Item Name: Crosstube Aft

D212-664-241 Rev D (DEO)
DSI9563 B

DART SERVICE INSTRUCTION

| DRAWING NO. D212-664-241 | TITLE CROSSTUBE ASSY (205/212 HI AFT) | REV. D | DART AEROSPACE LTD ENGINEERING ORDER | D.E.O. NO. D212-664-241-D-1 | SHEET NO. SHEET 1 OF 2 | SCALE NTS |

FIGURE 1: SUPPORT INSTALLATION

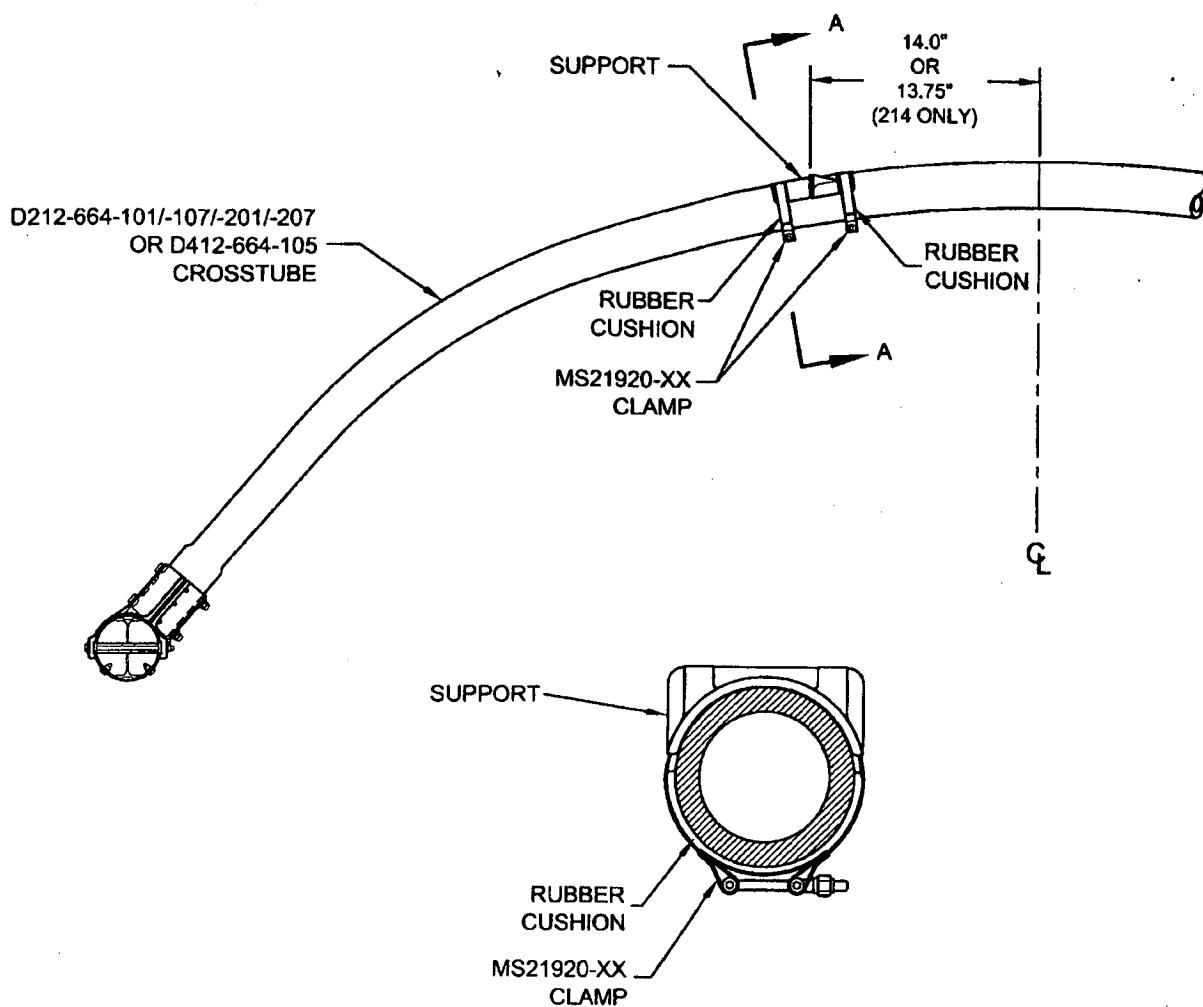
The supports on the following crosstubes are now installed using Proseal instead of Magnobond:

For the crosstubes listed above, section 32.4 of ICA-D212-664 is amended as follows. Use Figure 1 of this service instruction and Figures 32-2 to 32-9 of ICA-D212-664 for further reference. For crosstubes of an earlier change number, it is recommended that if the supports are removed, the supports should be reinstalled using the procedure listed below.

- 32.4.5 Apply a 0.04" to 0.07" thick layer of Proseal 890 Class B or AMS-S-8802 Class B sealant underneath applicable support and install support as shown in Figure 1 of this service instruction.

- 32.4.6 Install the clamps opposite to crosstube support as shown in section A-A of Figure 1. Install rubber cushions underneath each clamp around the bottom circumference of the crosstube up to the crosstube centerline. Torque clamps 80-100 in-lb (9.0-11.3 Nm). It is acceptable to use smaller or larger sized MS21920-XX clamps than those listed in ICA-D212-664, ensure that after torquing the clamps per this instruction, the nuts are in safety but not bottomed out.

D212-664-241/-241B
ASSEMBLY DETAIL

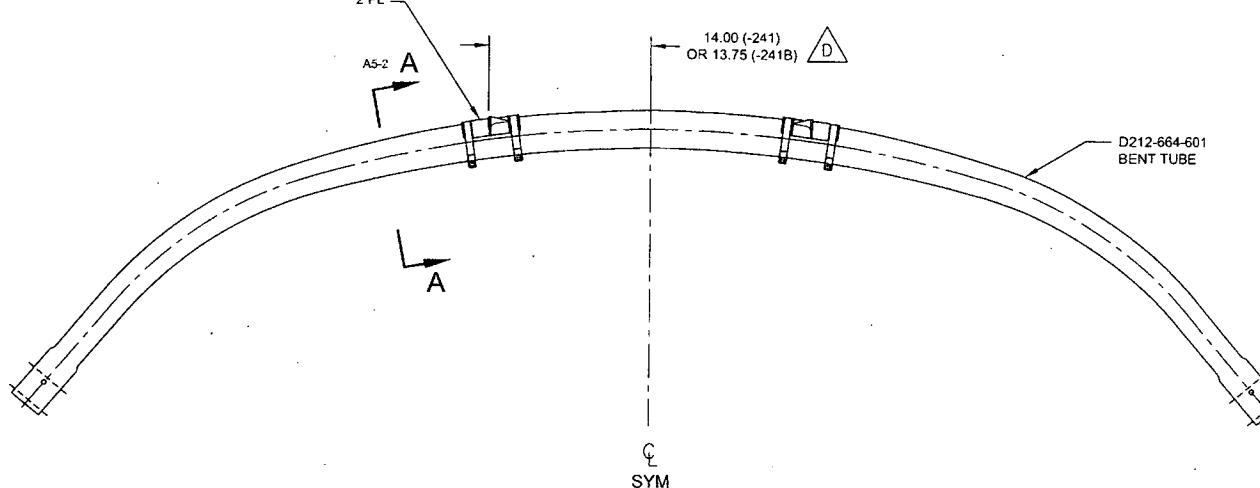
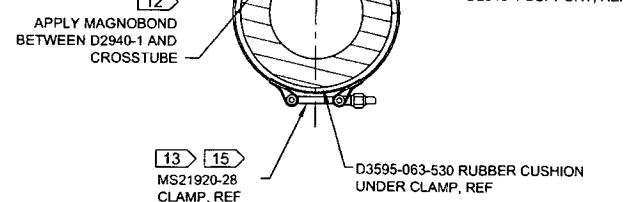
PURPOSE:
REPLACE MAGNOBOND WITH PROSEAL.

NOTE 12 & 15, SHEET 1 IS AMENDED AS FOLLOWS:

- 12) TO INSTALL D2940-1 SUPPORT: ABRADE MATING SURFACE OF SUPPORT AND CROSSTUBE WITH 180-GRIT SANDPAPER AND REMOVE RESIDUE WITH MEK (OR EQUIVALENT). APPLY A 0.04" TO 0.07" THICK LAYER OF PROSEAL 890 CLASS B-2 (OR AMS-S-8802 CLASS B-2) SEALANT TO MATING SURFACE OF SUPPORT.
- 15) TORQUE CLAMPS 80 TO 100 IN-LB. ENSURE AT LEAST 1.5 THREADS SHOWING IN SAFETY AND THAT NUT HAS NOT BOTTOMED-OUT AFTER TORQUING. PRIOR TO PACKAGING, RE-CHECK TORQUE ON CLAMPS AFTER PROSEAL 890 SEALANT HAS CURED FOR 72 HOURS.

D212-664-241/241B
ASSEMBLY DETAIL

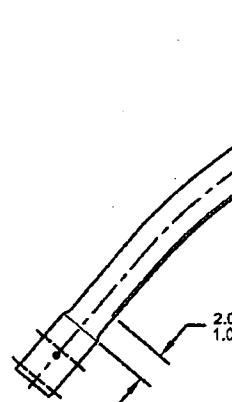
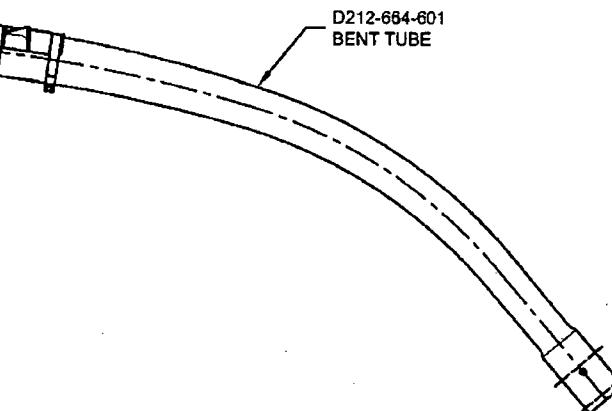
PURPOSE:
ADD AN INSPECTION WINDOW TO UNDERSIDE OF CROSSTUBE.

NOTES 2 OF SHEET 1 IS AMENDED AS FOLLOWS:

- 2) FINISH: CHEMICAL CONVERSION COAT PER DART QSI 005 4.1
PRIME INSIDE AND OUTSIDE PER DART QSI 005 4.2
MASK UNDERSIDE OF CROSSTUBE AS SHOWN (HATCHED AREA) AND
PAINT OUTSIDE PER DART QSI 005 4.2
REMOVE MASKING AND APPLY CLEAR COAT
